MODEL BD-700-1A10 (BD-700)

ATA 27-51 AND 32-41

**MODIFICATION – CONTROL AND INDICATION SYSTEMS –
 MODIFICATIONS TO PERMIT ZERO-FLAP TAKE-OFF CAPABILITY
 WITH FULL PERFORMANCE**

SERVICE BULLETIN

Location of the 10 Screws to be Removed
Figure 1

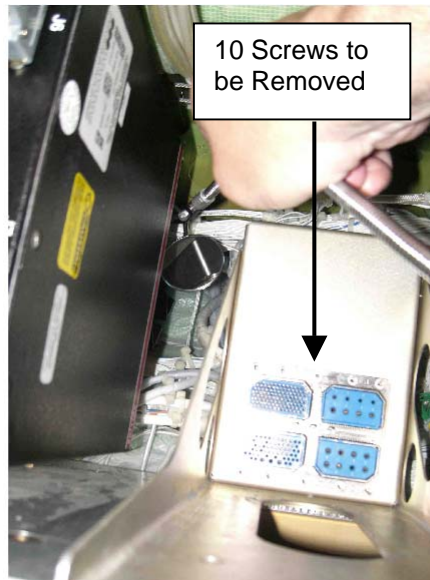
- (12) Remove the floor panels 241FLF and 242FRF. Refer to TASK 53-21-00-000-801.
- (13) Obey all electrostatic discharge safety precautions. Refer to TASK 24-00-00-910-802.
- (14) Do the modification as follows at the SFCU 1 (Refer to Figures 1 and 2 below):
- Remove the SFCU 1. Refer to TASK 27-51-05-000-801.
 - Remove the 10 screws that attach the four-insert connector to the back shells and the SFCU tray.

Location of Screws to be Loosened but not Removed
Figure 2

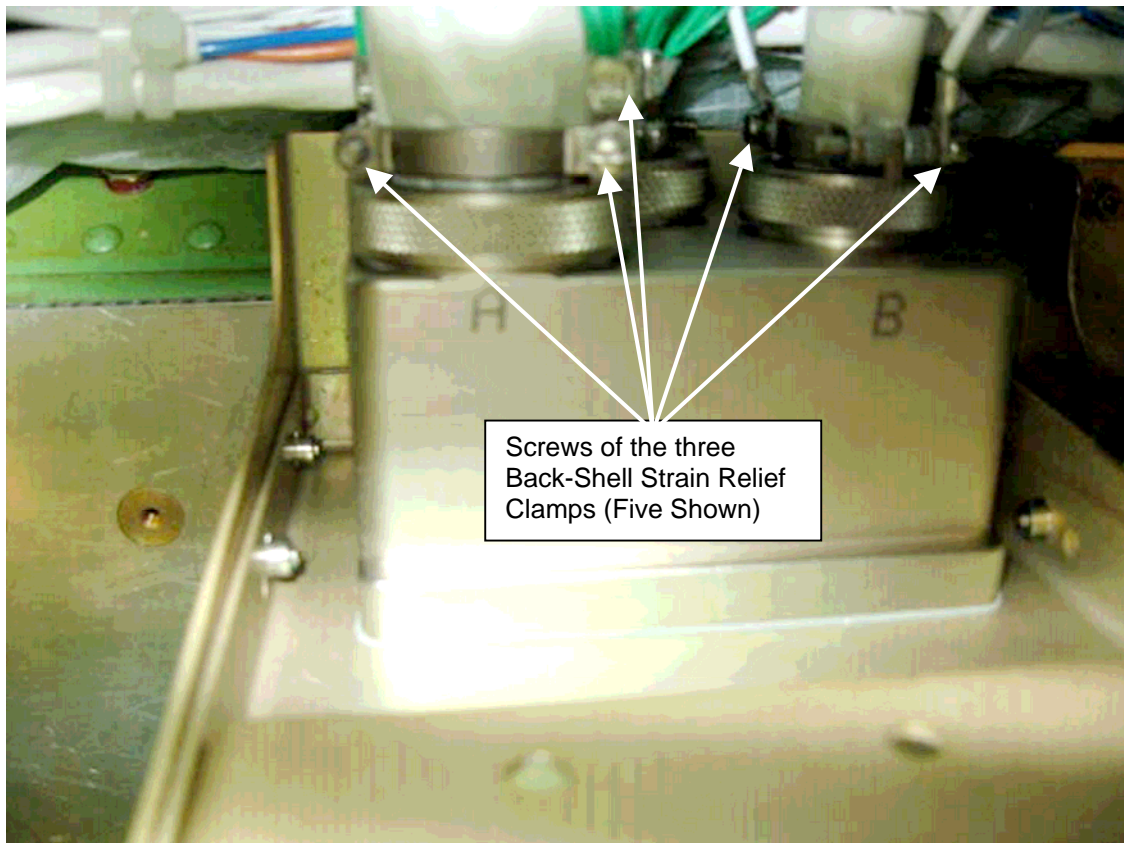
- (c) Loosen but do not remove the screws of the three back-shell strain relief clamps located behind the Electro-Magnetic Interference (EMI) back shell.

KGC991-7540 – Kit Drawing – Zero Flap Take-Off Capability (Slats Out)
(Sheet 1 of 2, Rev. A)

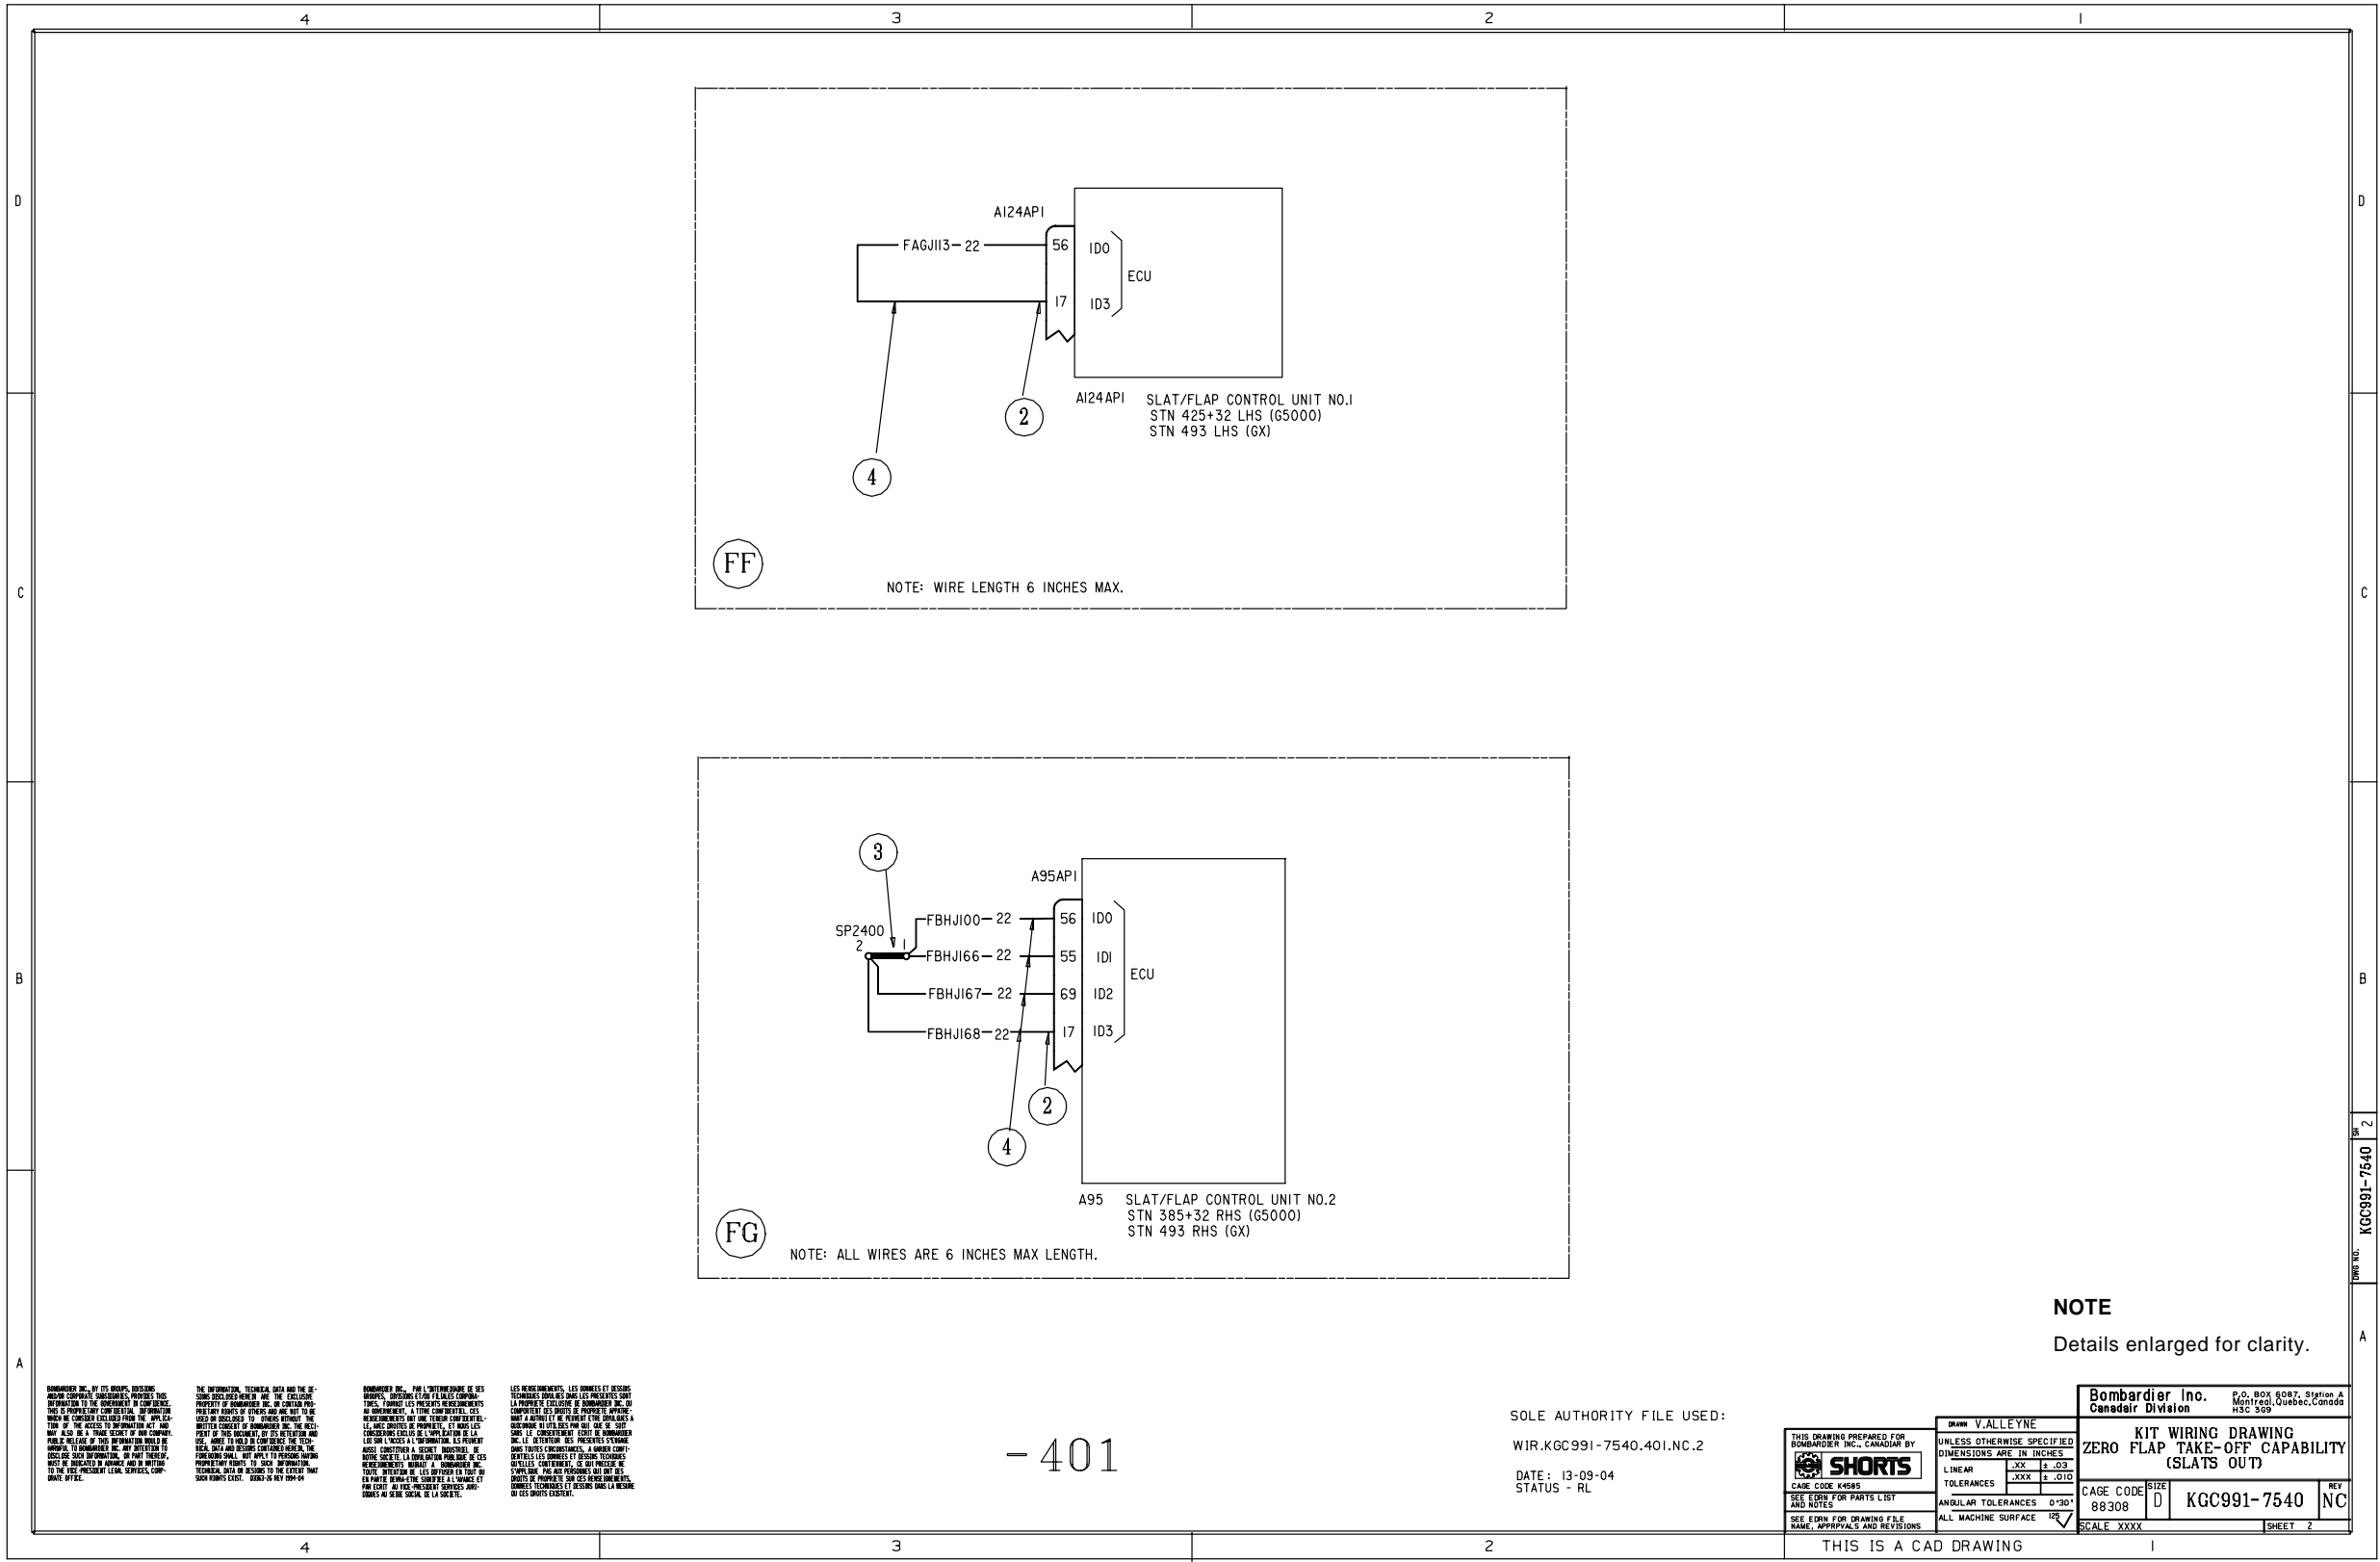
- EFFECTIVITY OF TABLE 1 & 2 AS PER SALES MATRIX
- INSTALLATION OF AIRCRAFT WIRING AS PER MPS145-3.
- IDENTIFICATION OF WIRES AS PER MPS145-5.
- RETERMINATE WIRES AND ADD NEW SPLICE SP2400 (ITEM#3):

FROM	WIRE CODE	IS TO	END TERMINATION	WAS TO	EFFECTIVITY
AI24API-56	FAGJ113-22	AI24API-17	030-1975-007	AI24API-55	-401
A95API-56	FBHJ100-22	SP2400-1	M81824/1-2	A95API-69	-401

5. ADD WIRES AS FOLLOWS:

END TERMINATION	FROM	WIRE CODE	TO	END TERMINATION	EFFECTIVITY
M81824/1-2	SP2400-1	FBHJ166-22	A95API-55	030-1975-007	-401
M81824/1-2	SP2400-2	FBHJ167-22	A95API-69	030-1975-007	-401
M81824/1-2	SP2400-2	FBHJ168-22	A95API-17	030-1975-007	-401

- (d) Pull the four-insert connector to get access to the wiring.
- (e) Do the wiring modification at the electrical connector A124AP1 as given in kit drawing KGC991-7540.
- (f) Push the four-insert connector back in position and install the 10 screws that attach the assembly to the back shells and tray.
- (g) Tighten the screws of the strain relief clamps of the three back shells.
- (15) Repeat the above step for the SFCU 2 (Refer to Figures 1 and 2 above) and do the wiring modification at the electrical connector A95AP1 as given in the kit drawing KGC991-7540.
- (16) Do a check for electrical continuity on all wiring introduced or disturbed by this Service Bulletin.
- (17) Install the SFCU 1 and 2. Refer to TASK 27-51-05-400-801.
